## Addendum-01

**NW827 - ANDERSON LIBRARY CONFERENCE CENTER - East Dock Renovation - IU# 20240675**  
**Indiana University Northwest**  
**Gary, Indiana**

Addendum Number One

THIS PRINT IS THE PROPERTY OF HUTTON & HUTTON ARCHITECTS & ENGINEERS AND IS CONFIDENTIAL. IT IS NOT TRANSFERABLE AND IS FURNISHED WITH THE CLEAR UNDERSTANDING THAT IT IS NOT TO BE TRACED OR OTHERWISE REPRODUCED WITHOUT PERMISSION AND IS RETURNABLE UPON REQUEST.

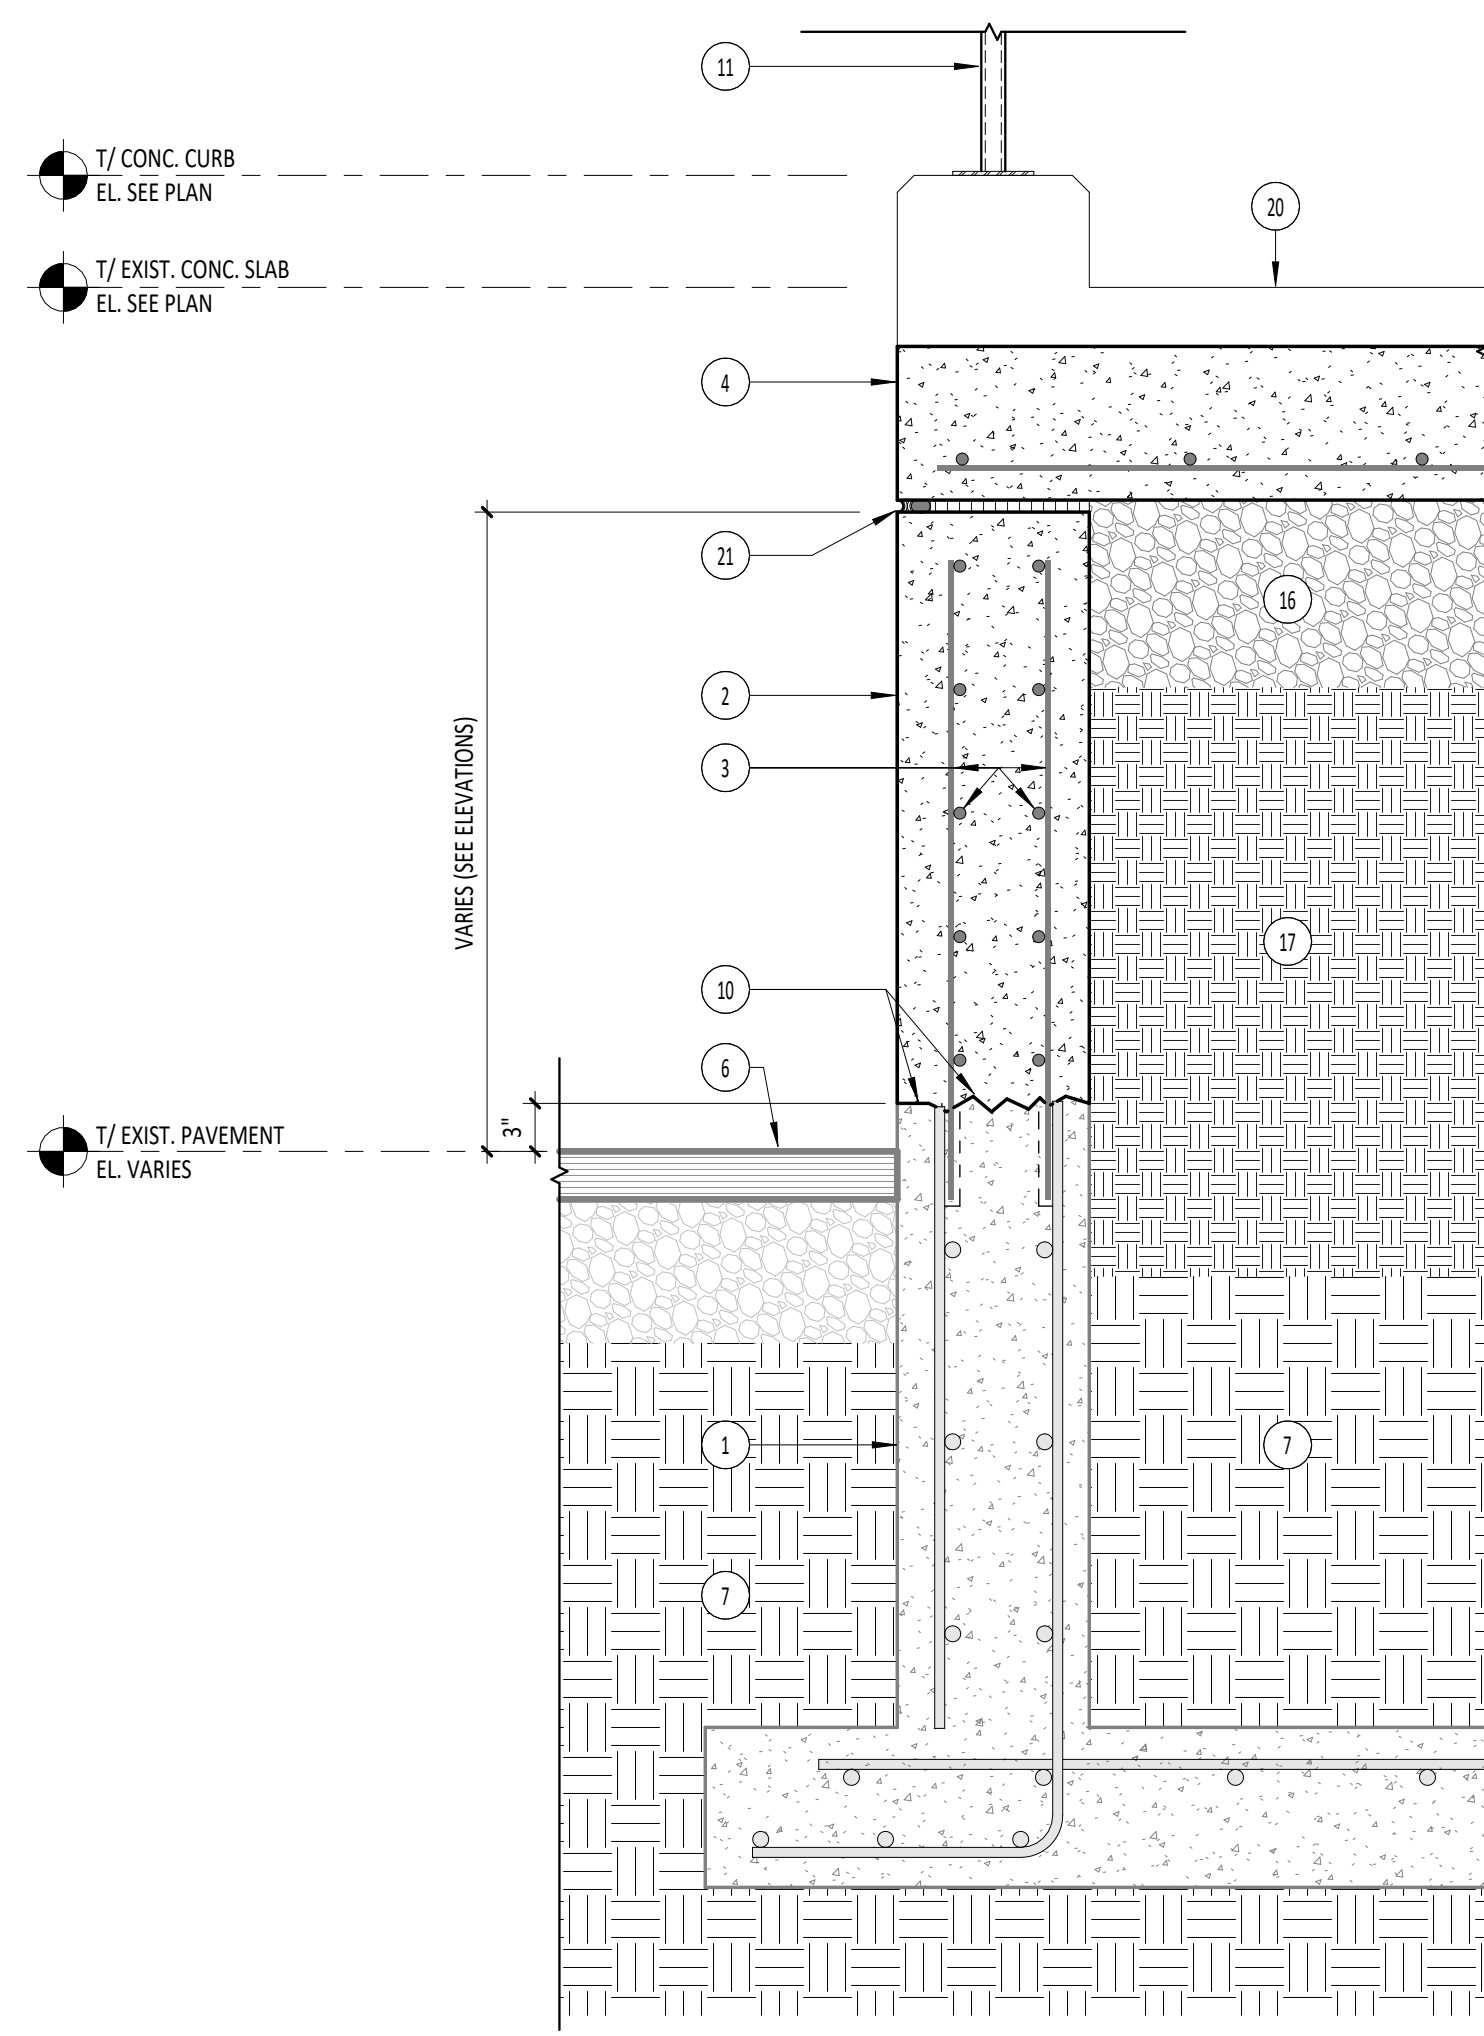
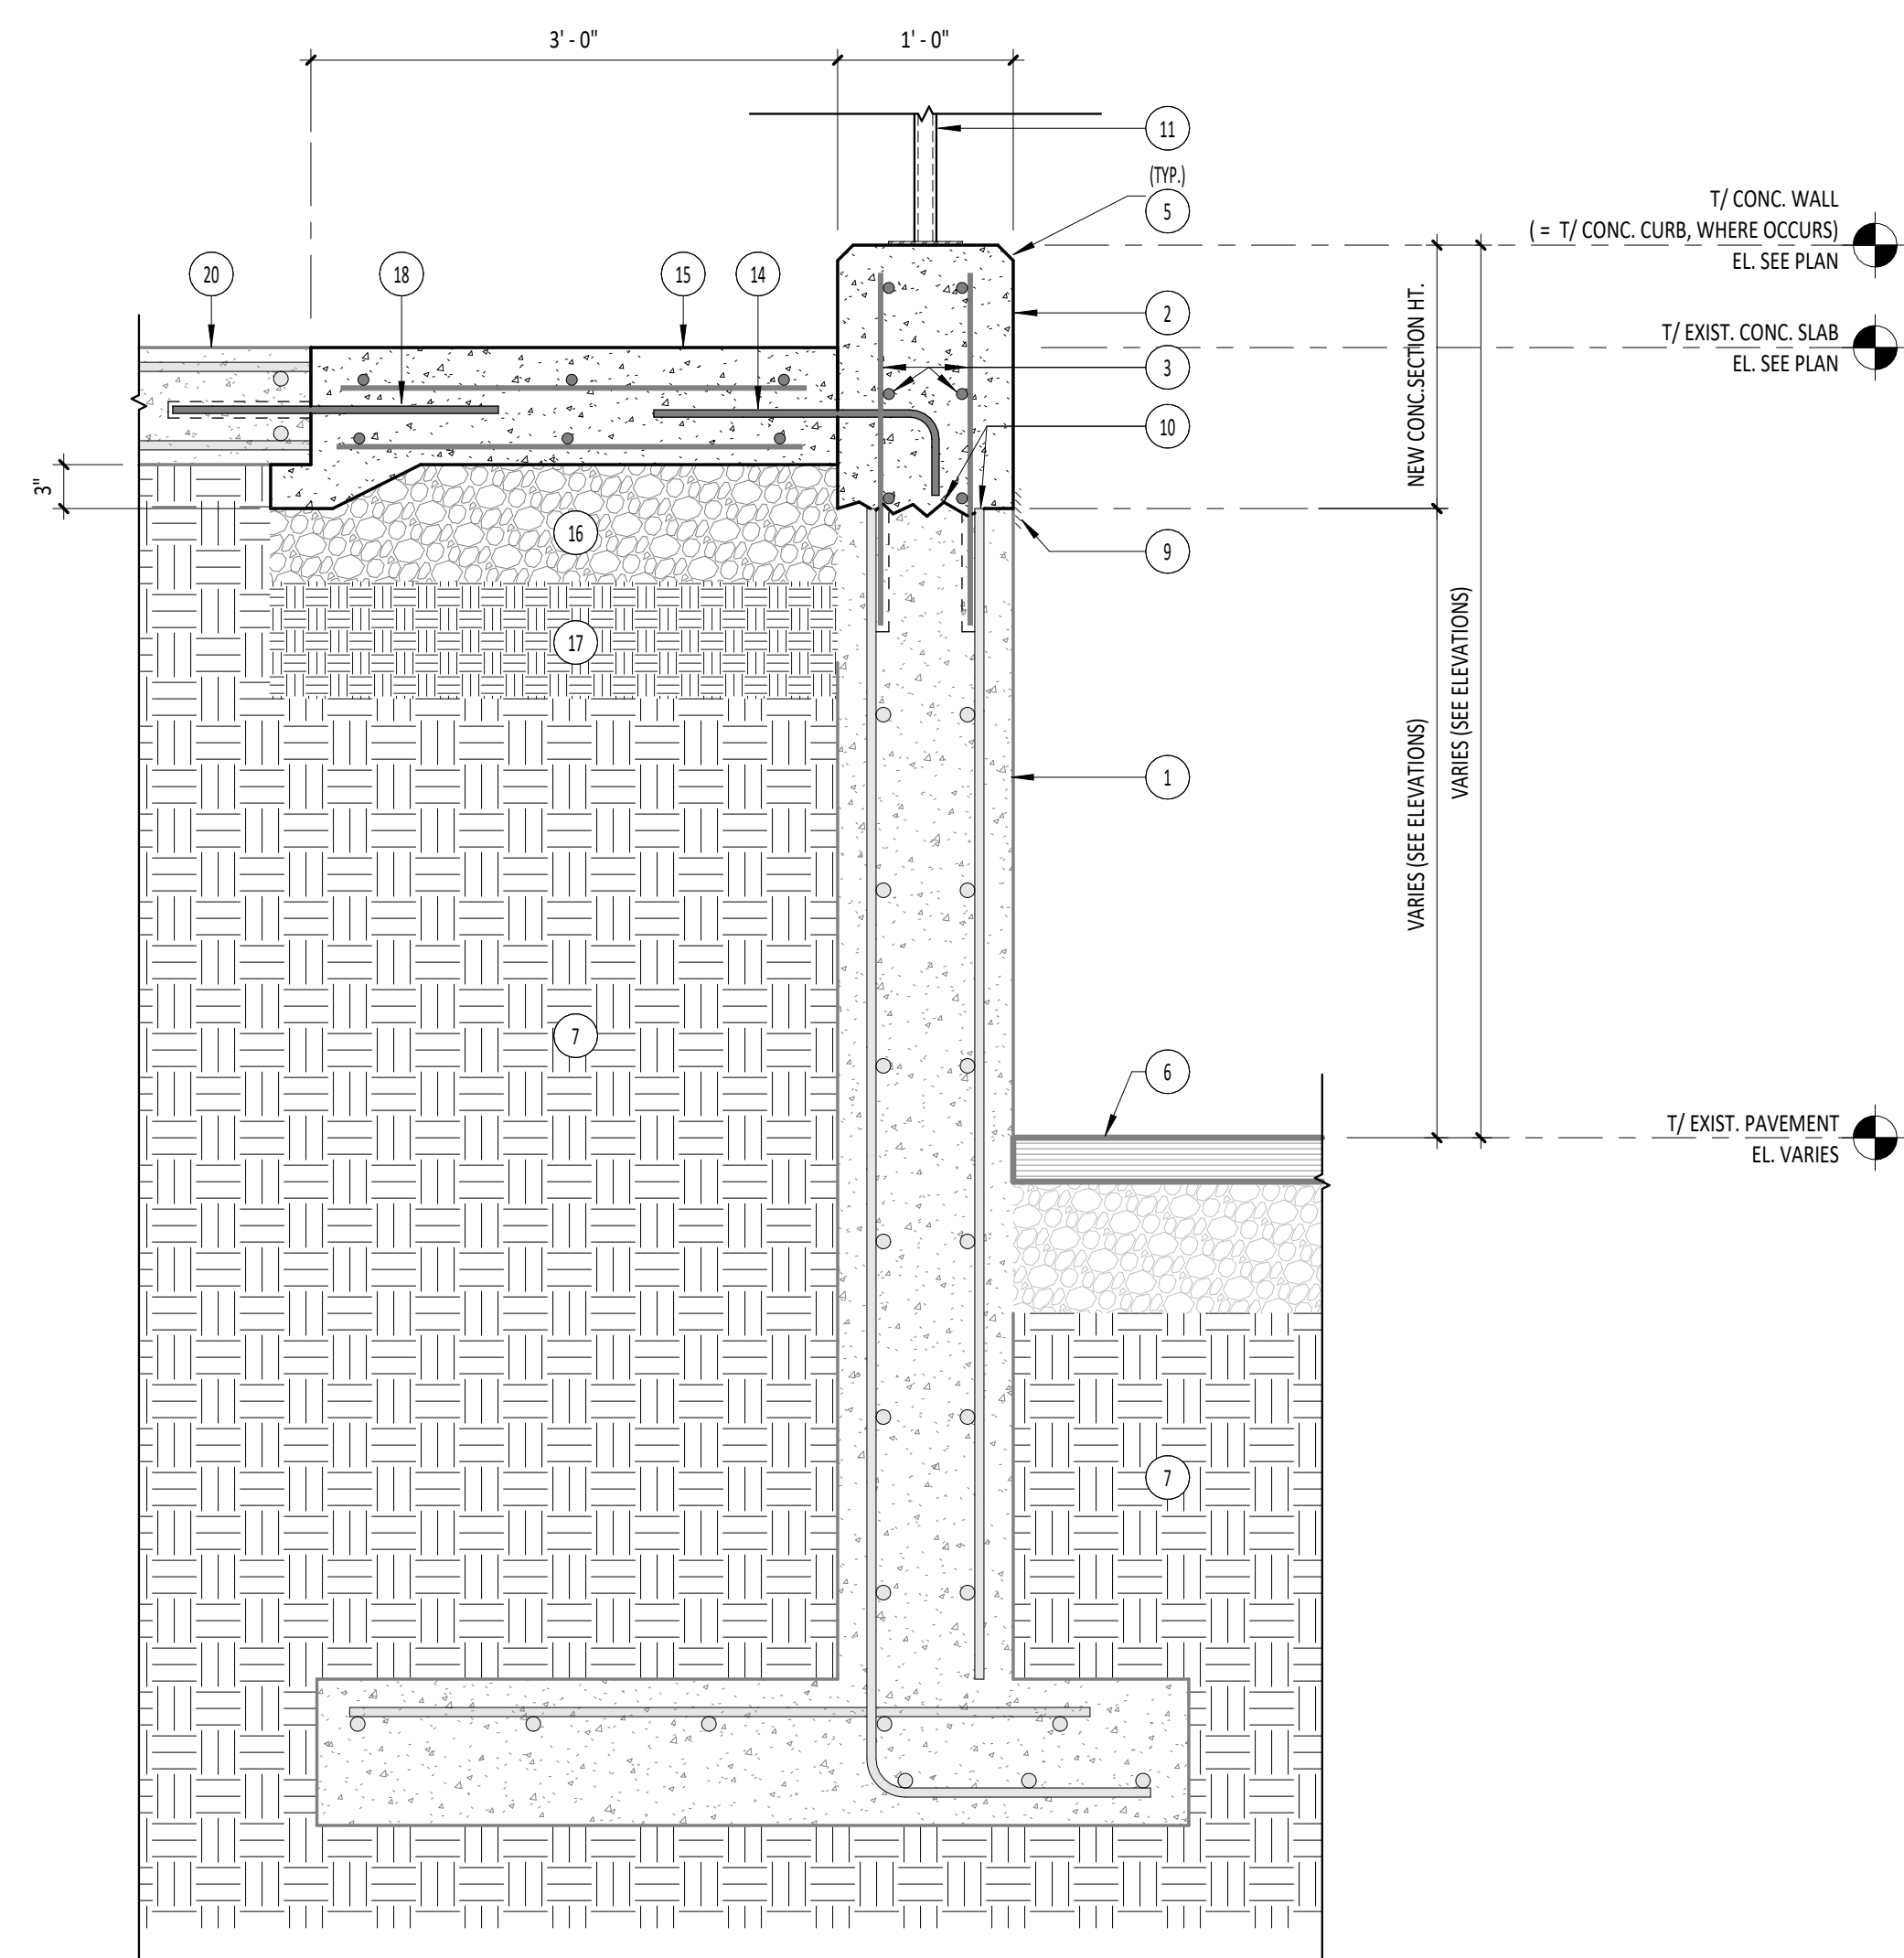
**1.03 Reference:** Revised sheet A4.0 - ENLARGED PLAN - LOADING DOCK STAIRS & DETAILS with revised date 25 April 2025.

**A. Clarification:** Section Detail Notes No. 11 & 12 were revised to reflect Drawing Item 1.02-A (above).

- 11 STAINLESS STEEL GUARDRAIL POST. REFER TO GUARDRAIL ELEVATIONS FOR FINISH TYPE.
- 12 3 1/2" X 5" X 5/16" STAINLESS STEEL BASE PLATE WITH FULL BED OF EPOXY SET INTO BELOW PLATE. REFER TO GUARDRAIL ELEVATIONS FOR FINISH TYPE.
